Owner: University of Maine

Engineer: DuBois & King, Inc.

SUBJECT: ADDENDUM NO. 2 TO THE BIDDING DOCUMENTS FOR

North Campus Parking Improvements

SHEET TITLE:
LONG RD EXISTING CONDITIONS & DEMOLITION PLAN ALT. 1

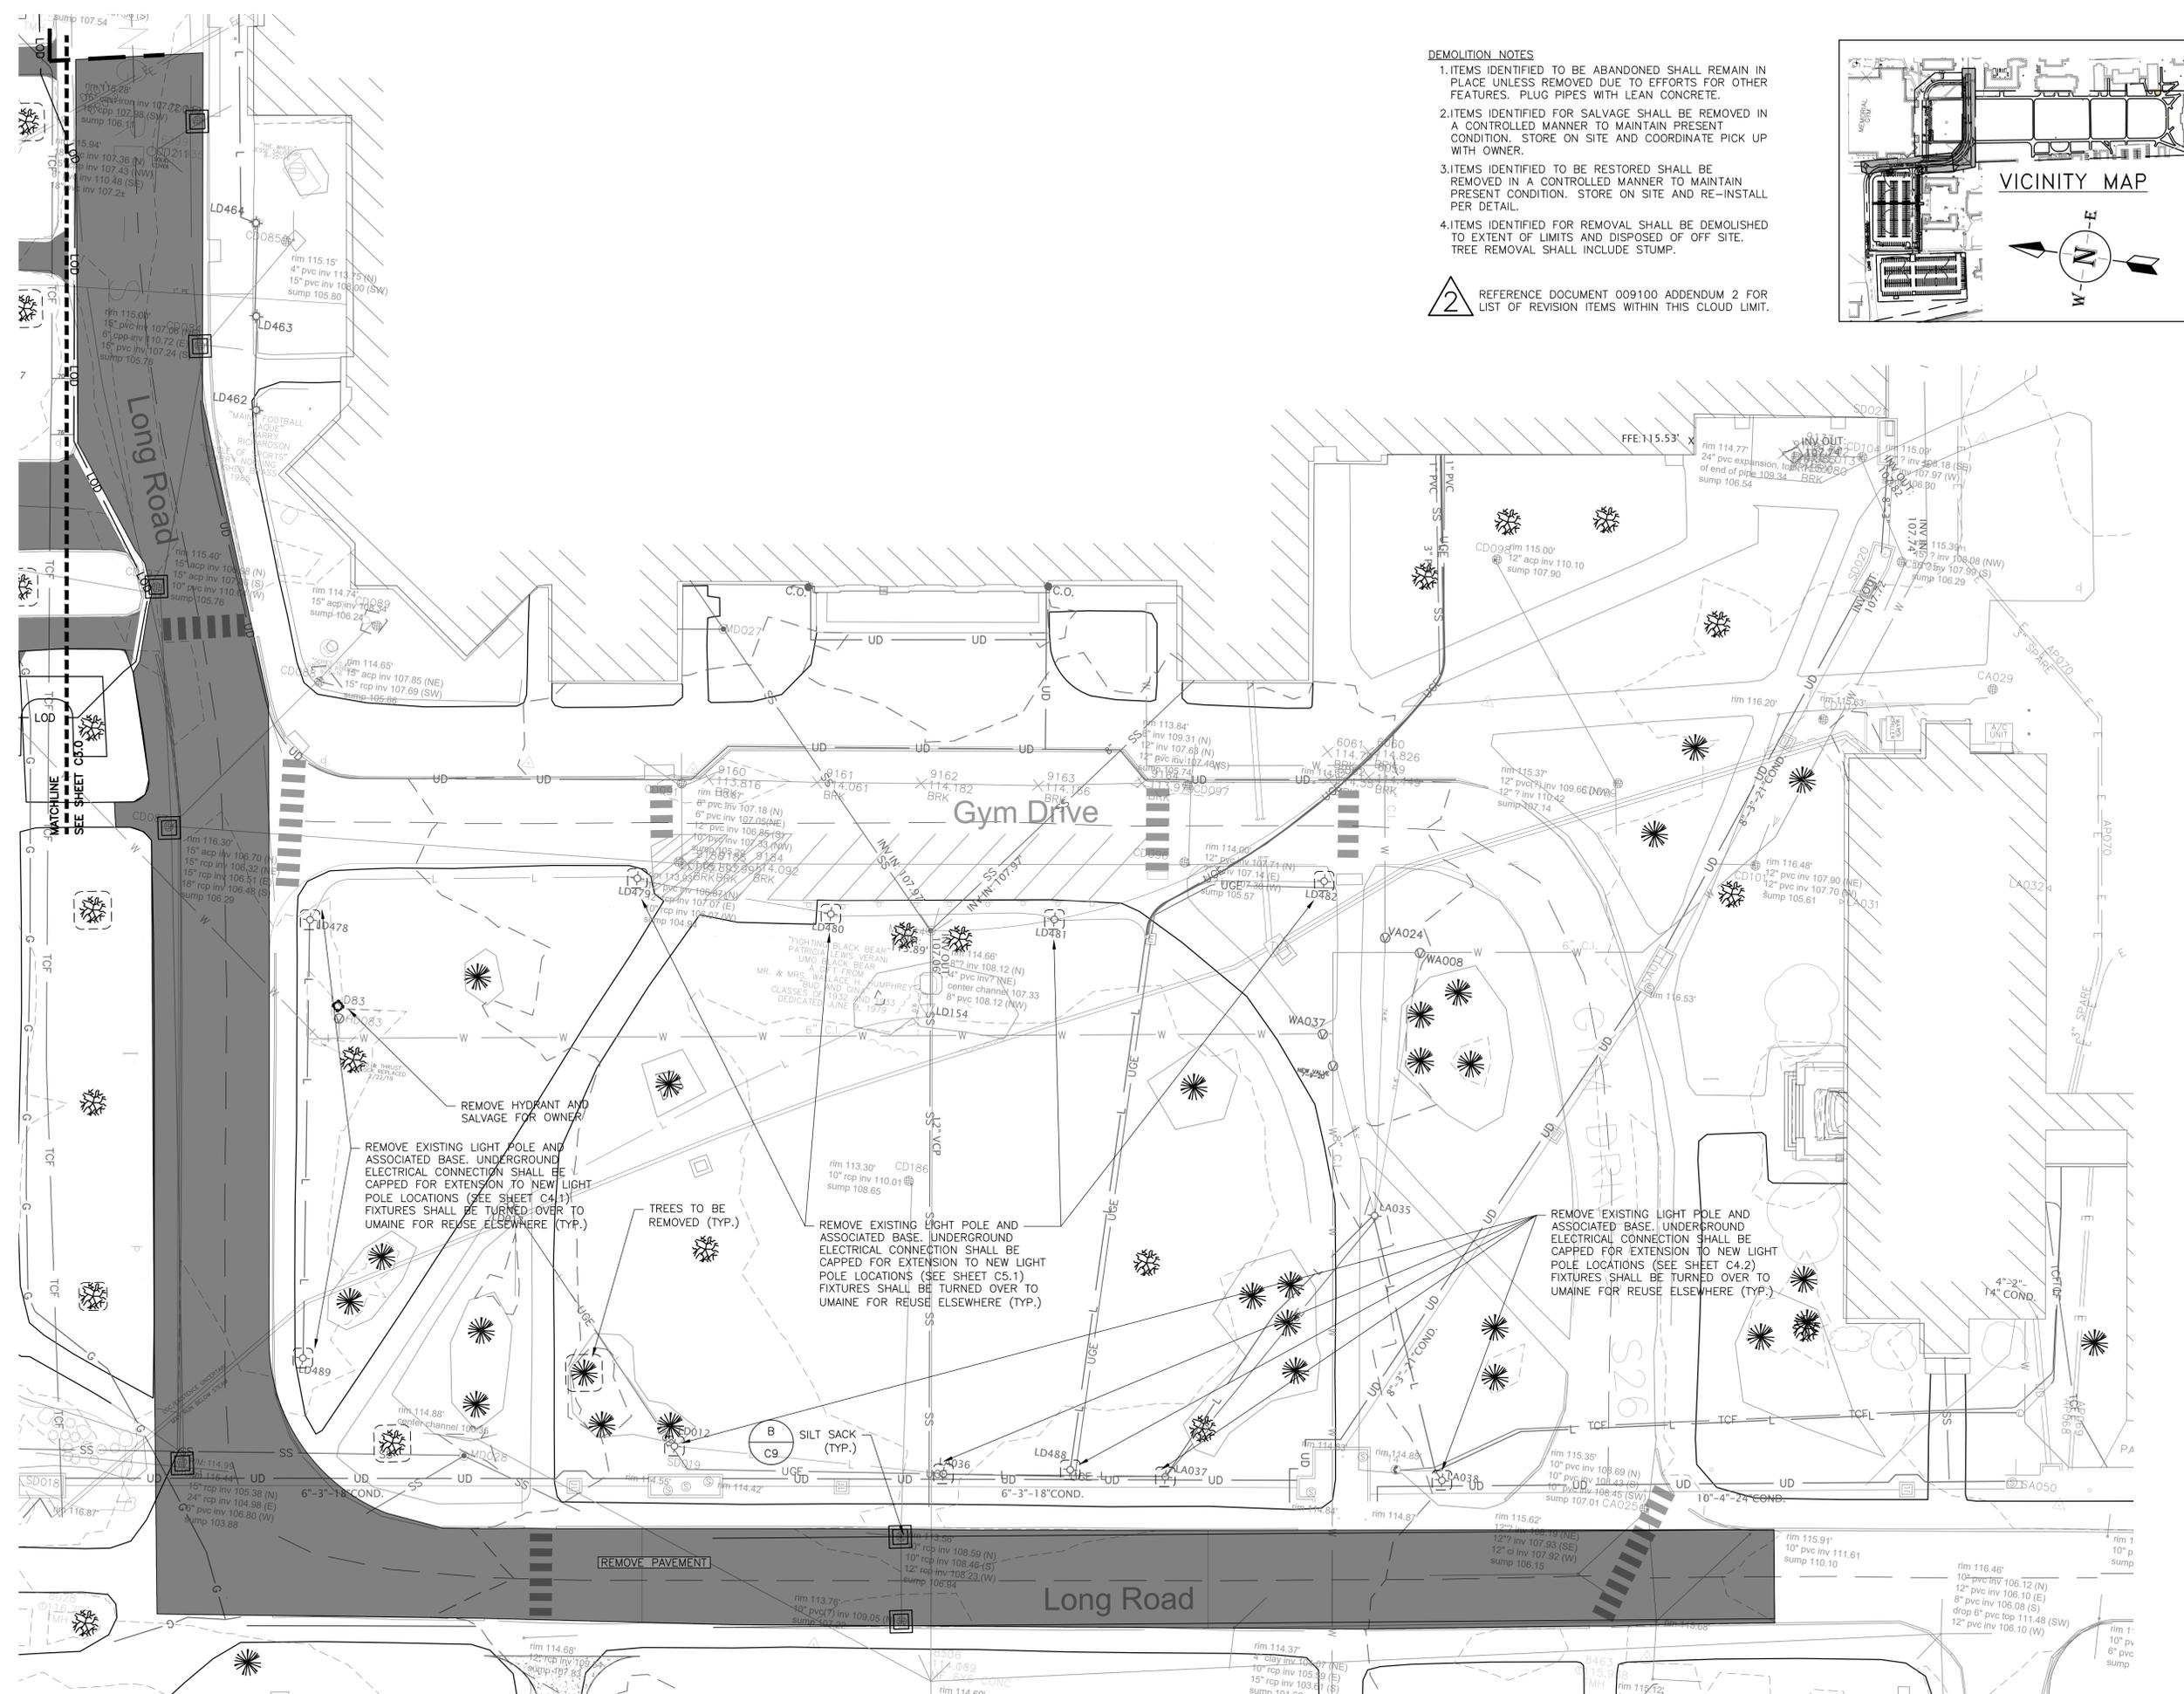
- j. Revised pavement Legend.
10. SHEET C4.0: Long Rd Existing Conditions & Demolition Plan Alt.1
 - a. Added SHEET C4.0.
 - b. Added demolition of catch basin in vicinity of Long Road Station 10+10. Connected pipe is asbestos cement pipe; abatement by Owner.

- c. Added remove and salvage of existing lighting including removal identifiers and notes; 7 lights along Long Road for Alt. 1 Work Area and 4 lights along Gym Drive for Alt. 2 Work Area.

- d. Added existing trees.
 - e. Added remove trees; 1 tree along Long Road for Alt. 1 Work Area and 1 tree along sidewalk for Alt. 2 Work Area.
 - f. Added remove pavement limits for Alt. 1 Work Area.

- g. Added remove and salvage fire hydrant.
 11. SHEET C4.1: Long Rd Plan & Profile Sta 4+65 to 8+50 Alt. 1
 - a. Revised drawing name.
 - b. Added match lines.

SHEET TITLE:
GYM DRIVE PLAN & PROFILE STA 20+00 TO 25+68 ALT. 2

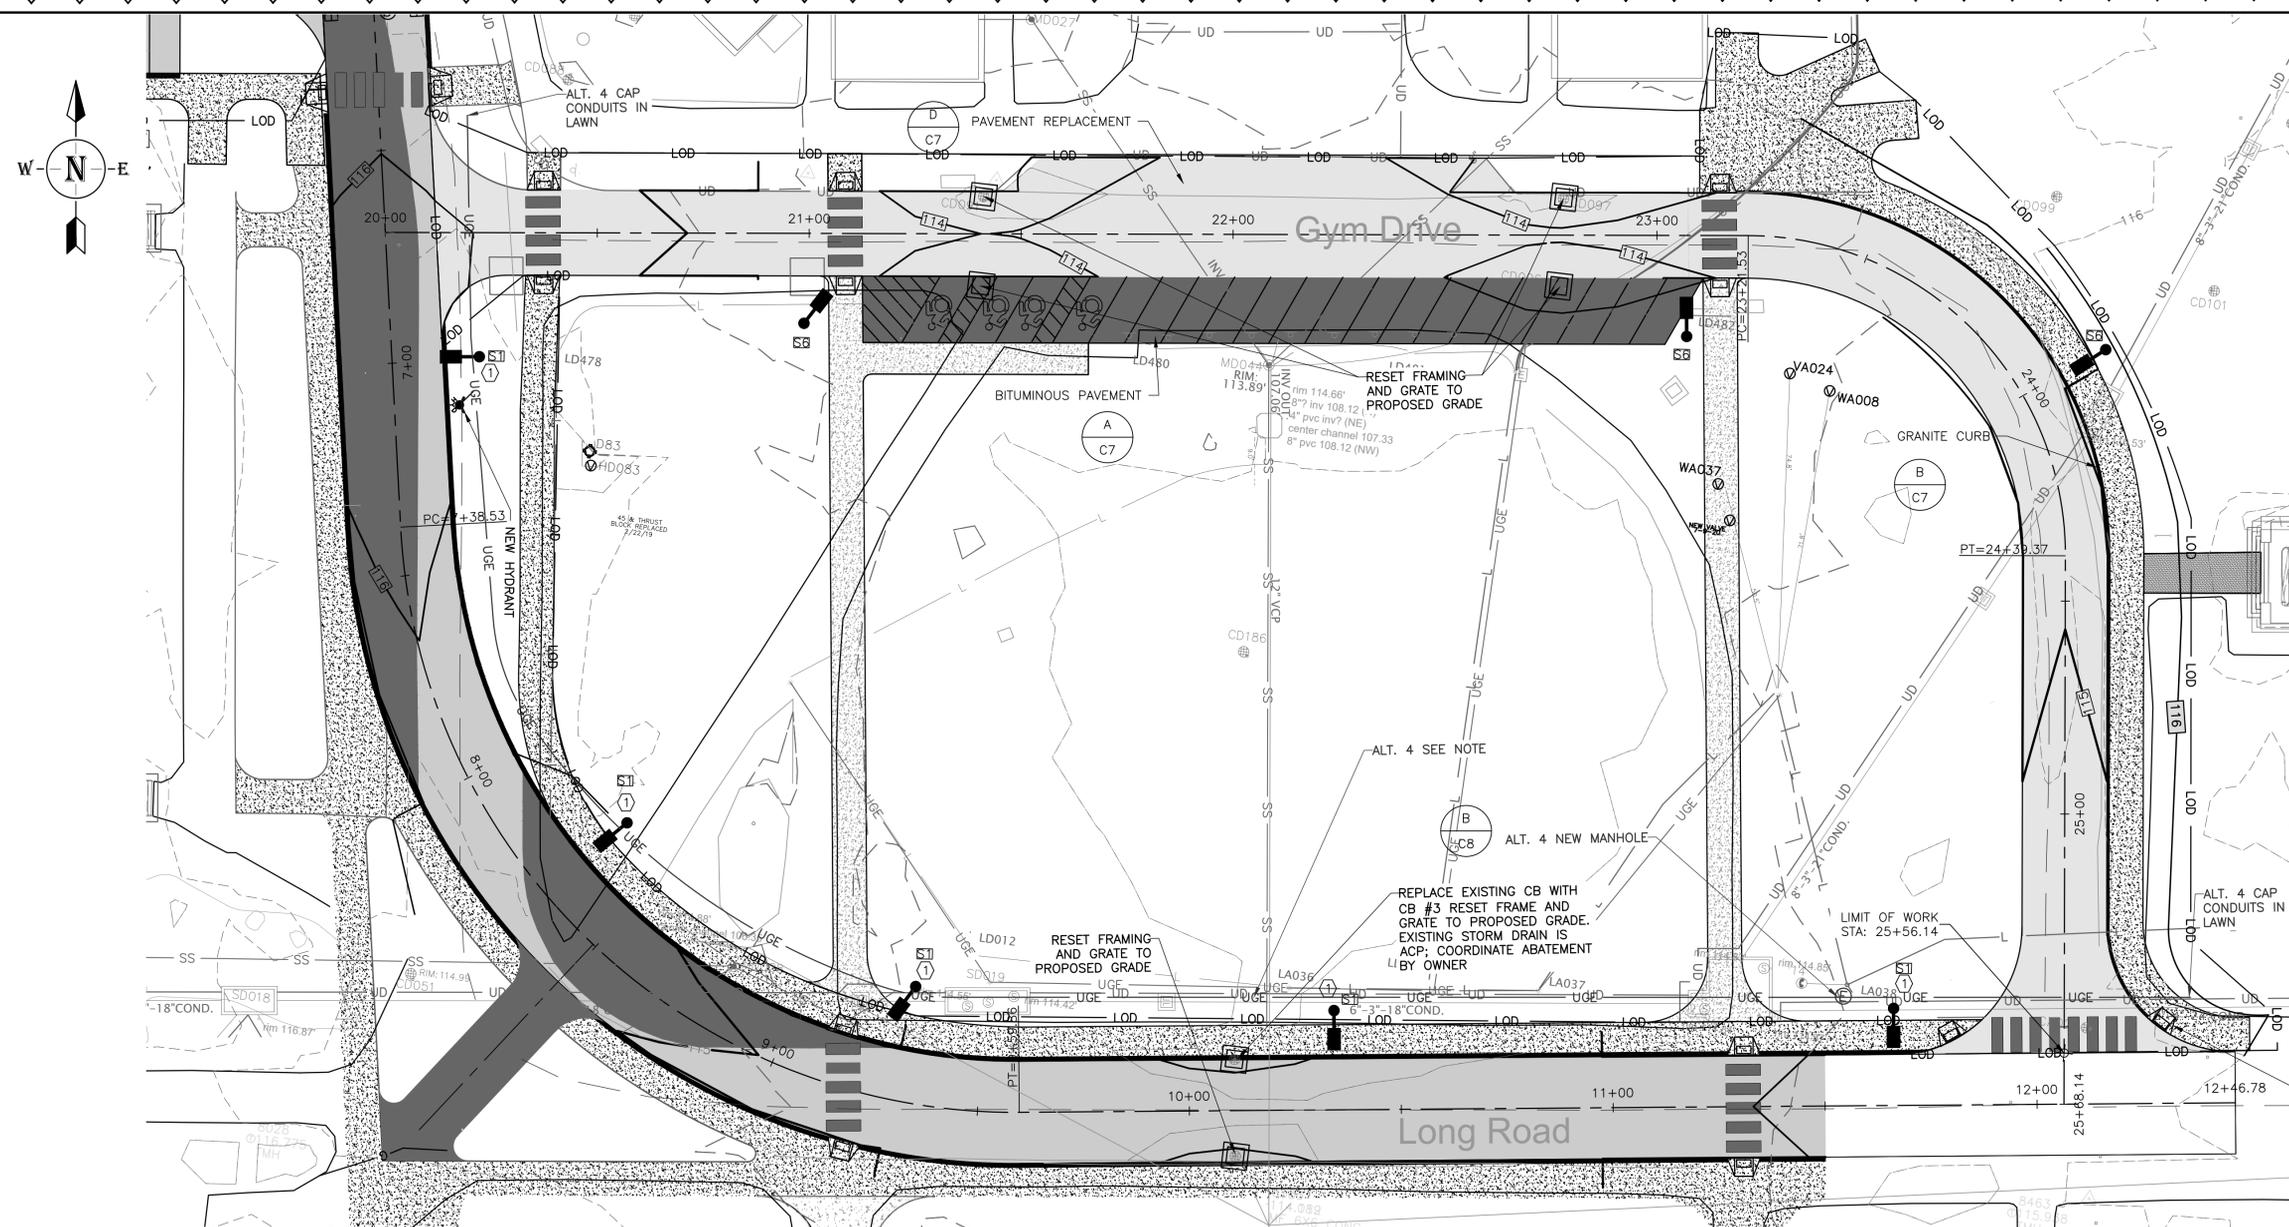
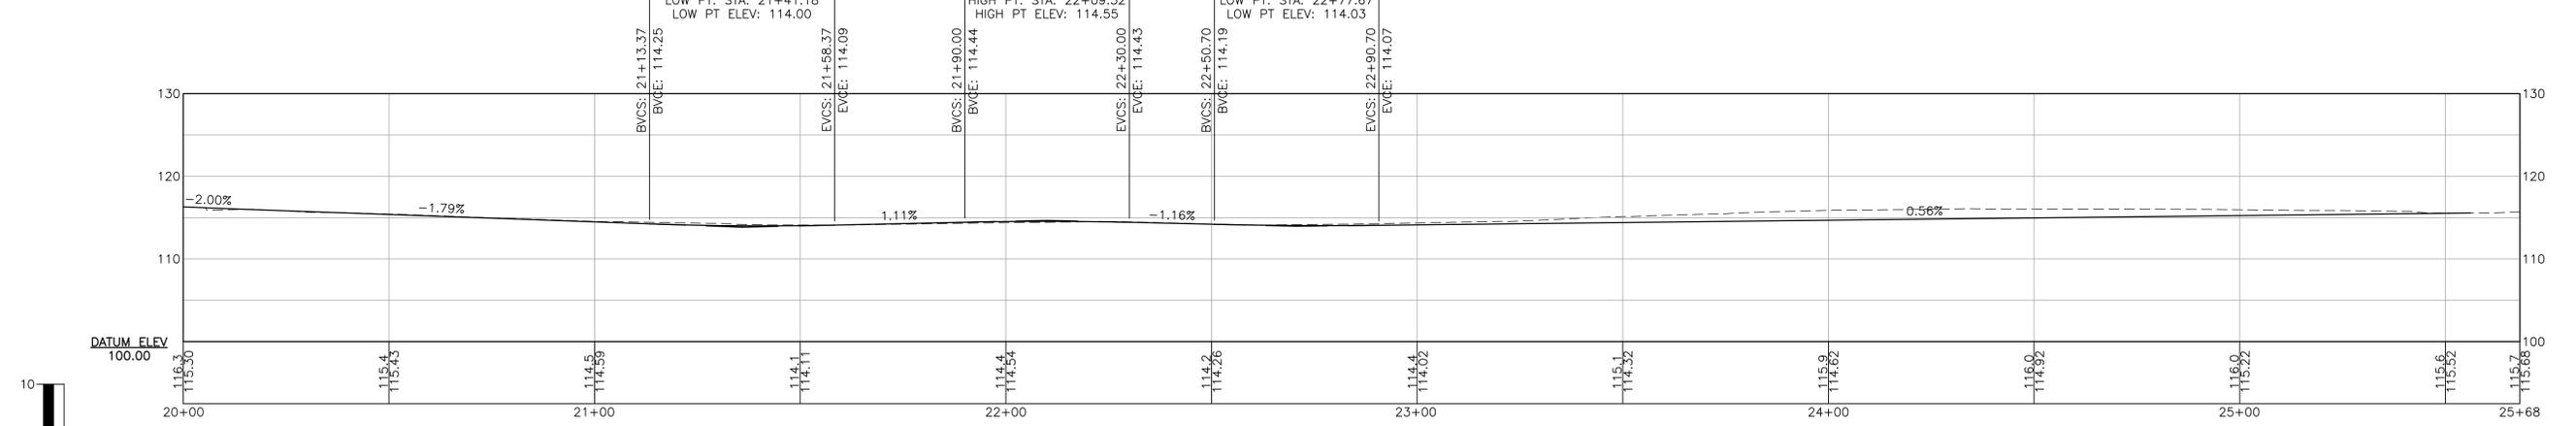
- j. Replaced lighting schedule.
 - k. Improved shading for bituminous pavement and pavement replacement.
 13. SHEET C5.1: Gym Drive Plan & Profile Sta 20+00 to 25+68 Alt. 2

- a. Revised drawing name.
 - b. Added match lines.
 - c. Revised limit of work limits.
 - d. Improved shading for bituminous pavement and pavement replacement.

- e. Added ADA tipdown locations including detectable strips.
 - f. Revised pavement Legend.
 - g. Added new site lighting locations, identifiers, and labels.

- h. Replaced lighting schedule.
 - i. Revised profile.
 - j. Improved shading for bituminous pavement and pavement replacement.
 - k. Added Alt. 4, Primary Underground Ductbank and notes.

ALTERNATE NO. 4
THE SCOPE OF WORK FOR ALTERNATE NO. 4 INCLUDES PRIMARY ELECTRICAL DUCTBANK ADJACENT TO LONG ROAD FROM STATION 6+30 TO STATION 12+35. SEE DETAIL D ON SHEET C8. CAP DUCTBANK IN LAWN AREA AT EACH END FOR FUTURE USE.

A BITUMINOUS PAVEMENT RECONSTRUCTION

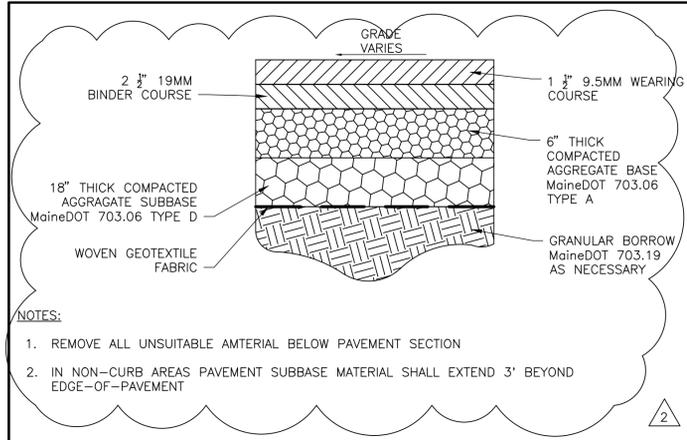
- 2. *It is specified that granular borrow be used for fills beneath pavement areas. Will the fill required on the backslope of the Wells Parking Lot have to be all granular or just a zone of influence from the edge of pavement?*

14. *The details for both new full depth pavement and pavement replacement show 1.5" surface on 1.5" binder. Please verify.*

15. SHEET C7: Site Details
- a. Revised Detail A for granular borrow and 2 ½” binder course.
 - b. Revised Detail C to remove limit on gravel shim.
 - c. Revised Detail D to remove limit on gravel shim.

Additional information is provided on Sheet C7 for granular borrow and fills associated with the backslope of the Wells Parking Lot.

Additional information on pavement materials is provided on sheet C7.

F DETECTIBLE WARNING DEVICE DETAIL

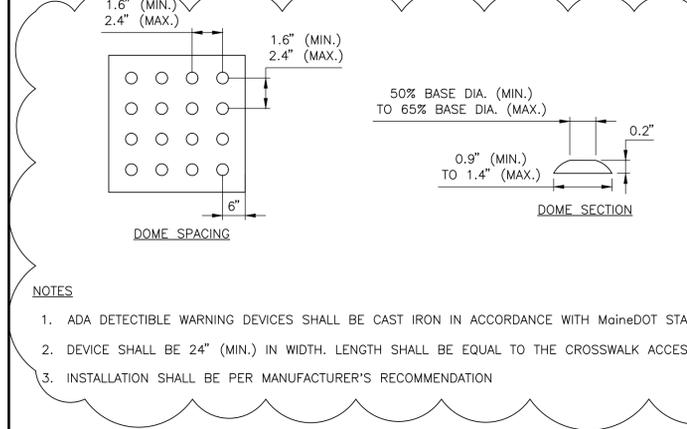
10. *Can a detail be provided as to what is required for casting the detectable warning plates in concrete?*

- d. Revised Detail F for concrete for accessible strip details.
 - e. Revised Detail H to add woven geotech fabric.
 - f. Revised Detail I to be Underground Electric Trench.

Additional information on casting detectable warning plates is provided on sheet C7.

J RESTORE MONUMENT FEATURES DETAIL

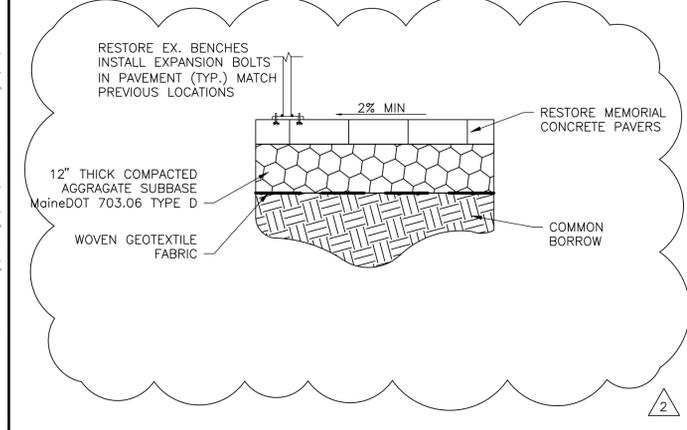
12. *What is required for the monument relocation? Concrete slab or anything like that? It appears the monument is stones and benches?*

- g. Added Detail J for restore monument features.
 - h. Added Detail K for Wells Lot Shoulder.
 - i. Relocated Details L and M from SHEET C8.
16. SHEET C8: Site & Utility Details

Additional information on the monument relocation is provided on Sheet C7.

C BITUMINOUS SIDEWALK REPLACEMENT

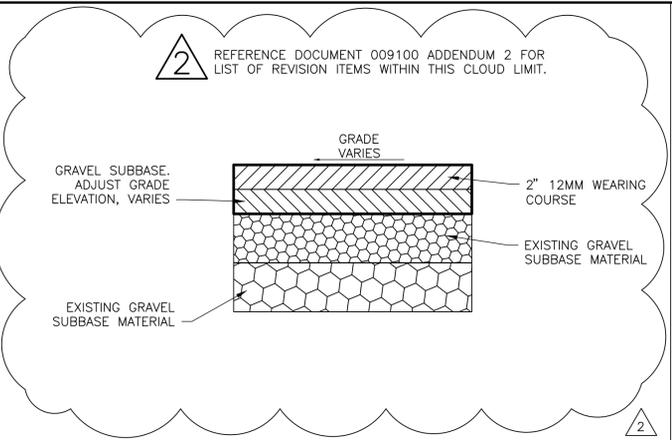
- 1. *For shim areas indicating gravel 1"-3" thick can pavement millings be used to satisfy the shim requirement?*

Pavement millings may be provided for gravel shim areas for a maximum thickness of 3". Provide specified gravel for shim depths greater than 3".

E CATCH BASIN DETAIL

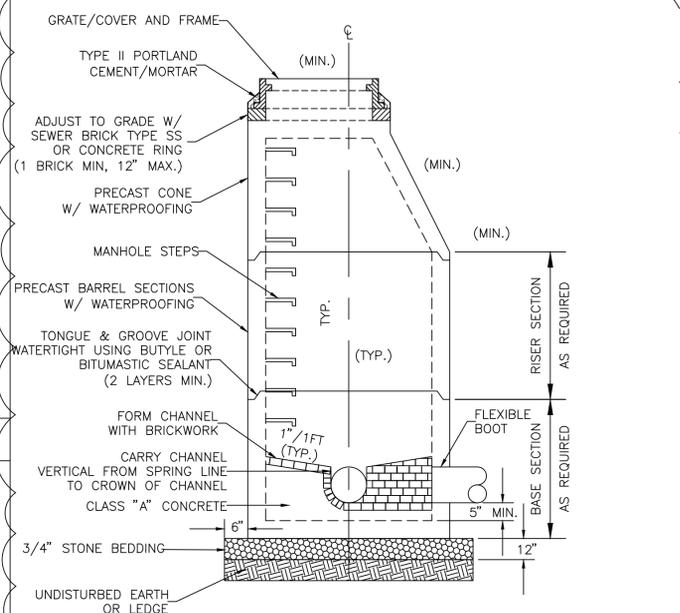
- b. Added Detail E for Catch Basin.
 - c. Added Detail F for Drain Manhole.
18. SHEET C10: Erosion & Sedimentation Control Notes
- a. Revised drawing name.
